Village of Palmetto Bay DUV Assessment

Dover Kohl & Partners
Marcela Cambor & Associates
July, 2017

SECTION I: DUV REVIEW

Figure 1

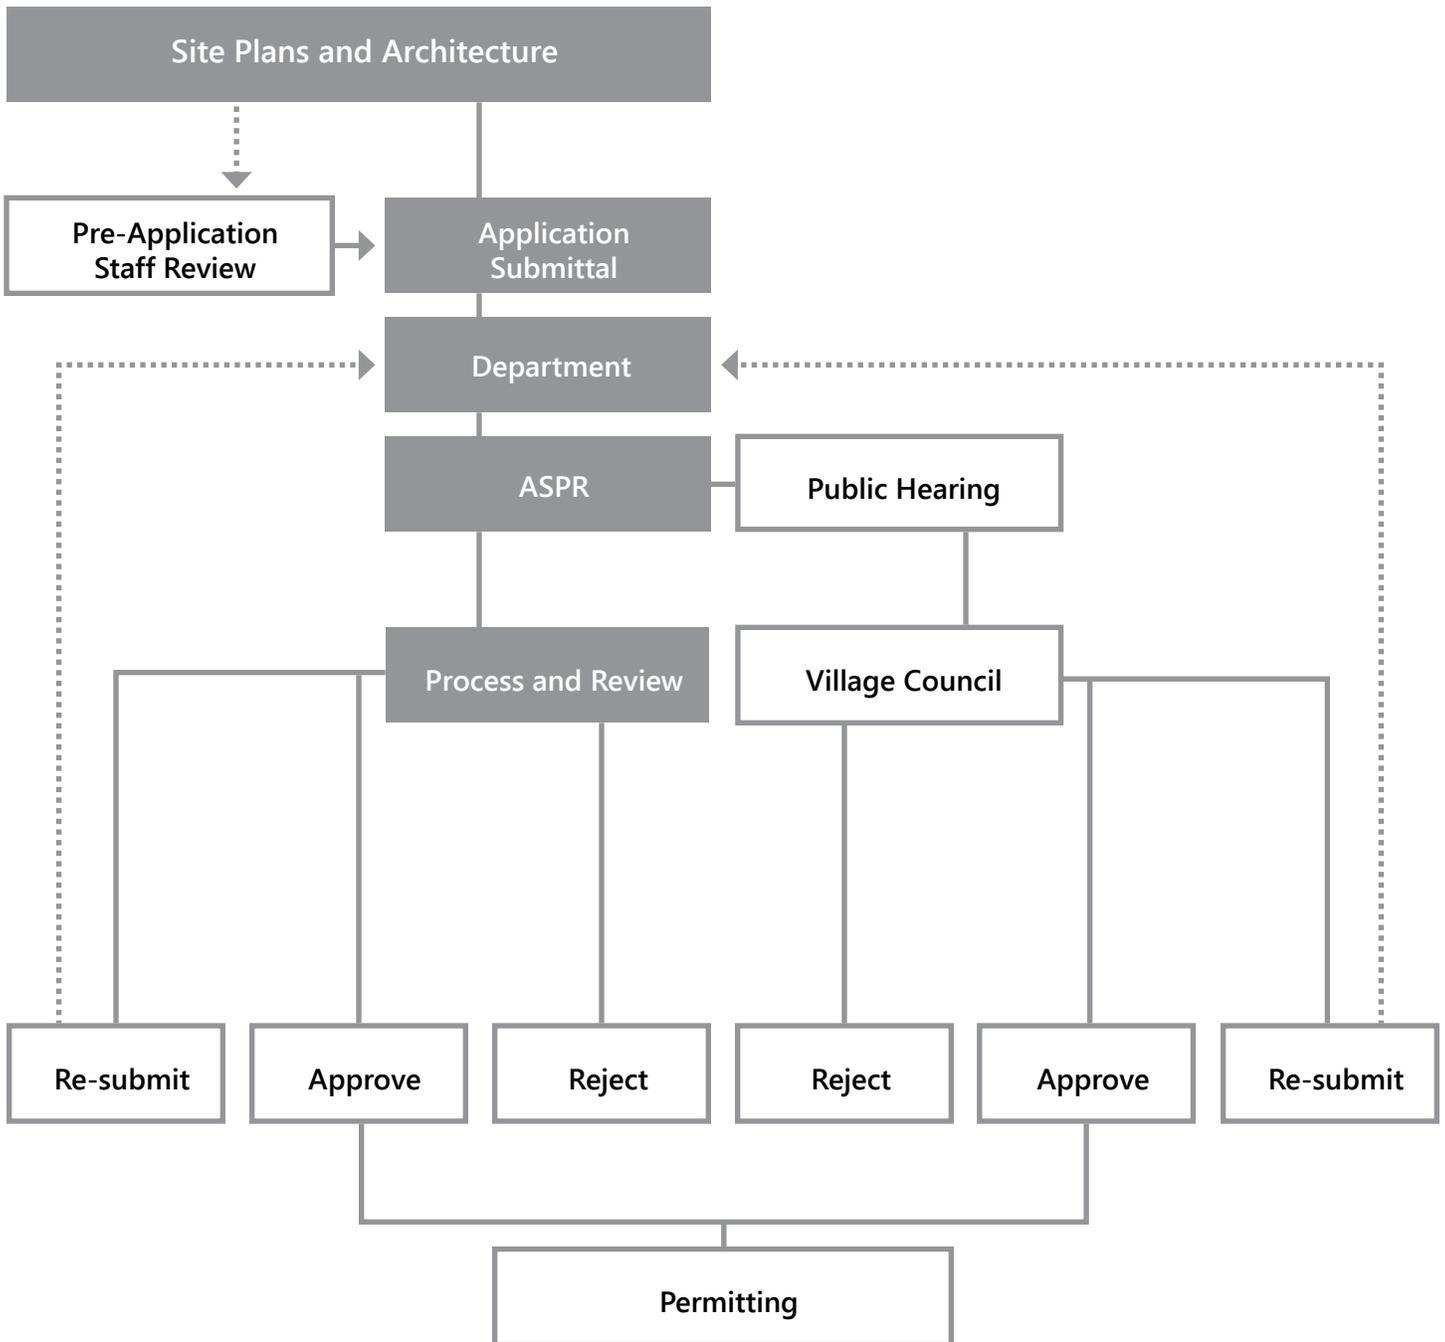
Note 4: The code states clearly that limitations may be imposed.

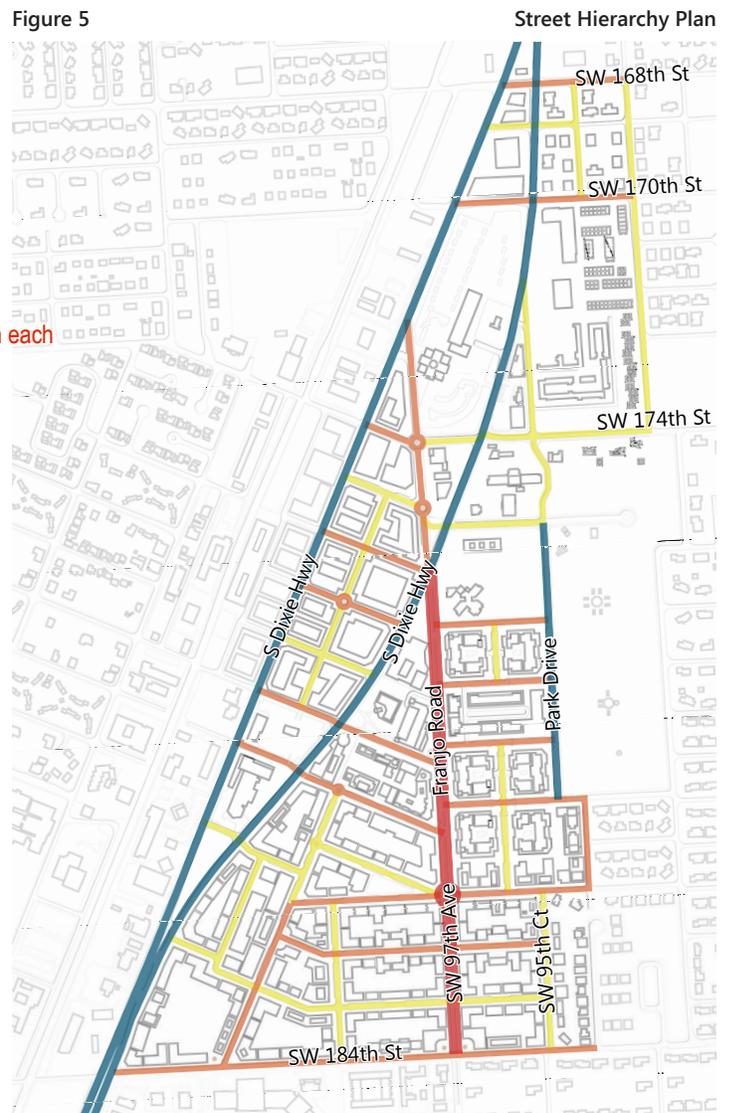
Note 13: Incomplete description of A & B streets. How should buildings behave in each situation. What is the difference between Priority A and A? Priority B and B?

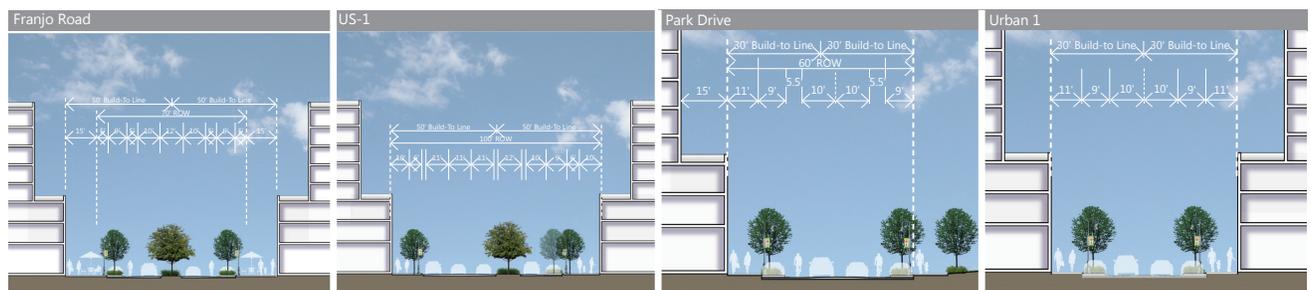
NOTE 19: The Downtown Village (DV) will set the character for the community. It is the area identified in the code as the center of the community, where residents and visitors alike will go to dine, shop, find entertainment, as well as live and work. However, the regulatory framework doesn't differentiate this area to be the most unique and special within the Village from the DG except in that it defines a lower "minimum" height. Minimums don't define differences relative to space, character or use. The Village needs to clearly define its objective for this area and the bonuses (if) offered, should be reflective of those goals. Is the intent to develop a vibrant Village center? Then bonuses (if) offered should further this principle. Is the intent to maintain a smaller-scale feel? Then the form should respond accordingly. The regulatory language for this zone, like all others, should include appropriate transition to other zones, in particular those that are less dense/intense.

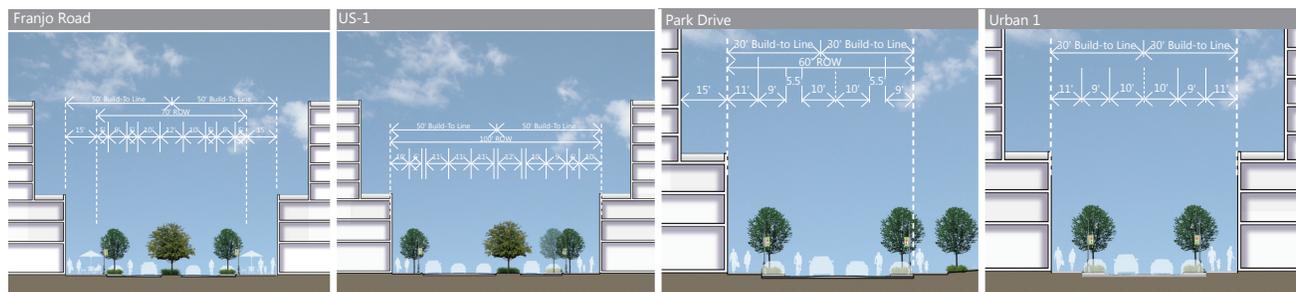
NOTE 23: The Downtown Village (DG) defines the impression most visitors and passers-by will have of the Village. It's general location is along roads serving more intense transportation needs. As such, buildings and uses along it need to be more resilient. Properly placed and designed buildings with increased heights, density and intensity respond well to these more intense ROW's. If there is a place for higher density/intensity in the Village it is the DG. If the Code's intent for this area is to provide density that supports ridership (TOD) and local businesses, then the regulatory framework and bonuses (if) provided need to be tailored to this objective. If there is a concern that these buildings will generate more traffic congestion, these buildings should be designed to reduce that impact. Minimum parking allowances and penalties for exceeding those should be considered.

NOTE 23B: If a transit-supportive area is to be successful the Village needs to work with the County to define the location of the future transit stop. Concurrently, the Village needs to define local transportation system that serves the community and feeds the larger system. As proposed the DG zone is 1.25 miles long. Even if a station were centrally located, the distance would prove too long for people to effectively walk to a station.

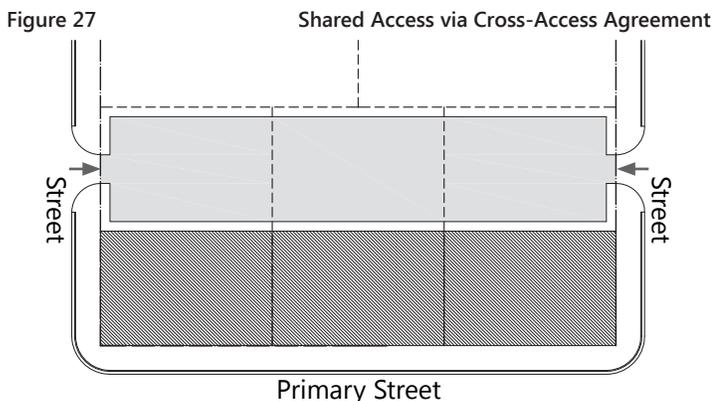
Where is the centralized parking system identified/defined?

Flexible Block Massing

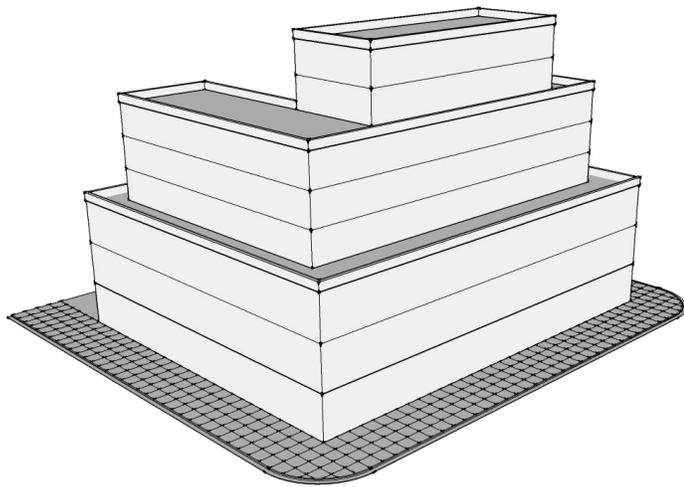
Graphic shows a decrease in floor plate as building increases in height. Is this regulated?
